11 GREAT BASIN RESOURCE WATCH  
12 APPEAL OF NOTICE OF DECISION  
13 TO RENEW WATER POLLUTION

14 CONTROL PERMIT NEV2008106 TO  
15 EUREKA MOLY, LLC FOR THE  
16 MOUNT HOPE PROJECT

**PETITIONER'S RESPONSE TO  
NEVADA DIVISION OF  
ENVIRONMENTAL PROTECTION'S  
AMENDED MOTION TO DISMISS**

Figure 1. Map source Final EIS Mt Hope. Purple circles are estimates of the quarter mile withdrawal zone around the springs.

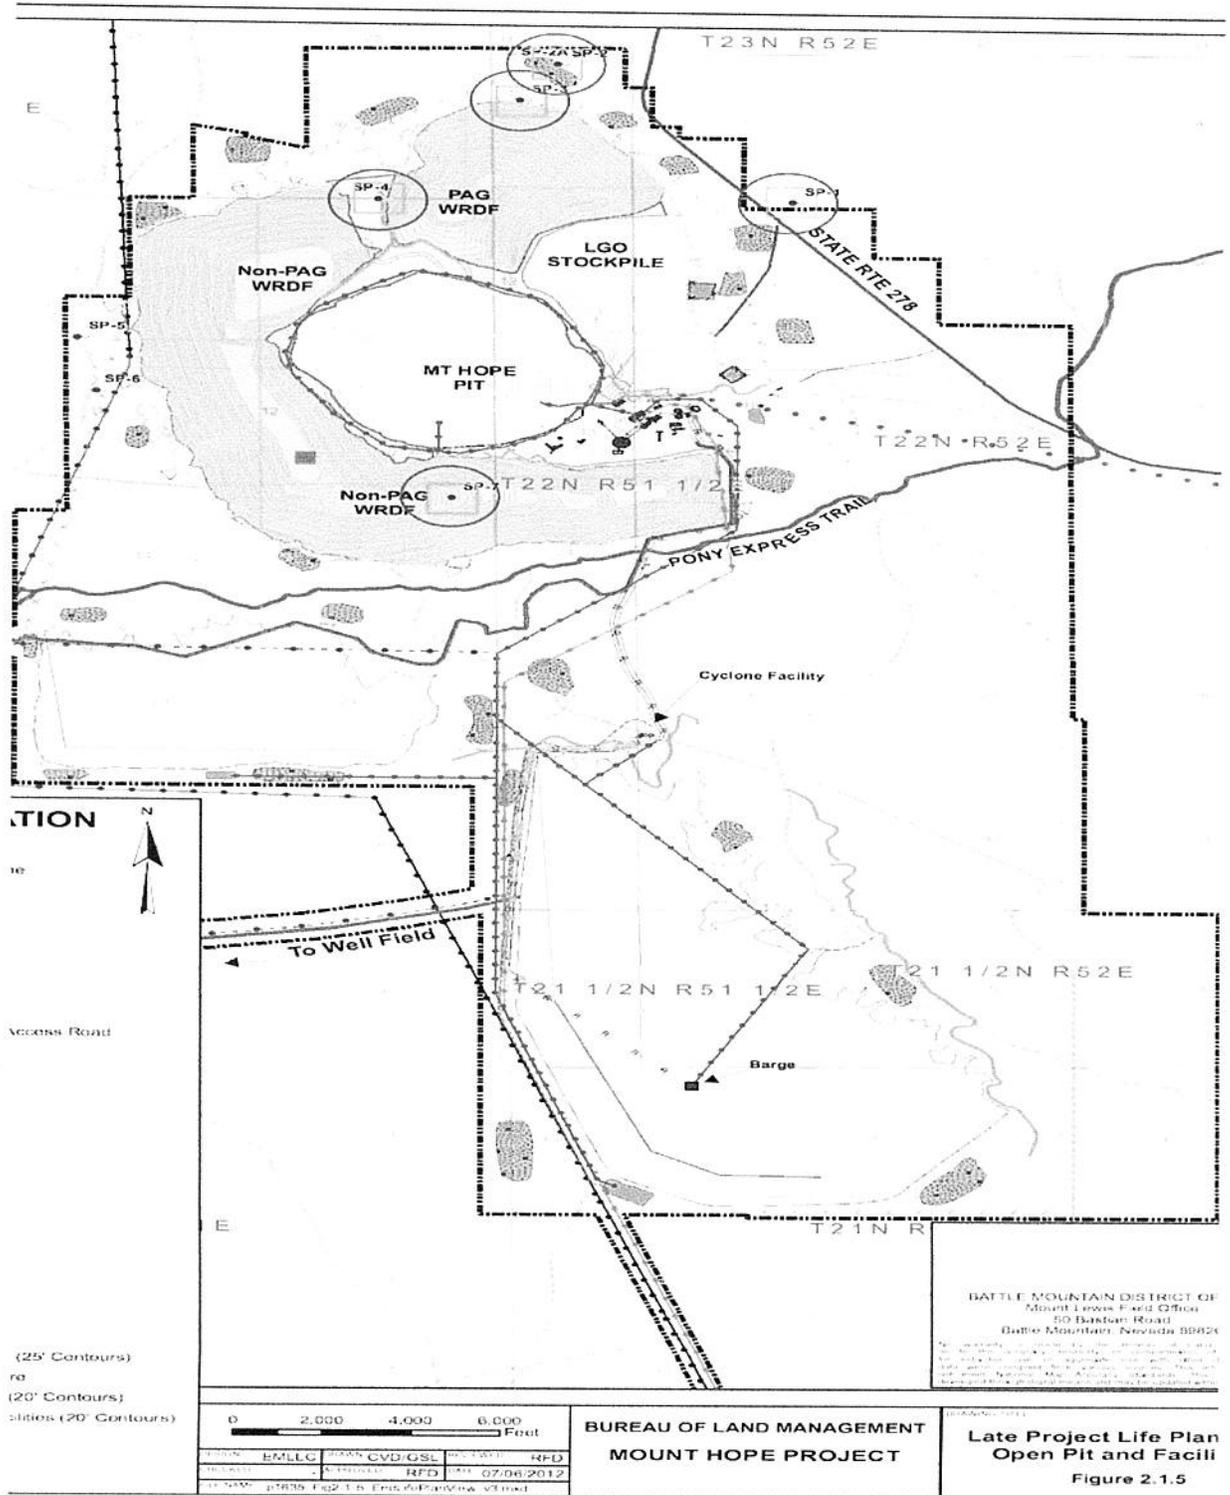
NDEP states that drainage from a potentially expanded PAG WRDF will affect the two  
springs SP-3 and SP-4. However, these two springs have been determined to be Public Water  
Reserves (PWR) by the Bureau of Land Management. Springs and waterholes on public land in  
the West are reserved for public use by Public Water Reserve No. 107 ("PWR #107"), which was  
created by Executive Order by President Calvin Coolidge in 1926. PWR 107 provides:

8 As PWR's access to the springs as well water quality and water quality is important, and  
9 it is a violation of federal law to deny or impede access to these springs. Even the existing  
10 footprint for the PAG WRDF is likely to violate PWR 107 let alone an expansion of the footprint  
11 (see Figure 1 below).
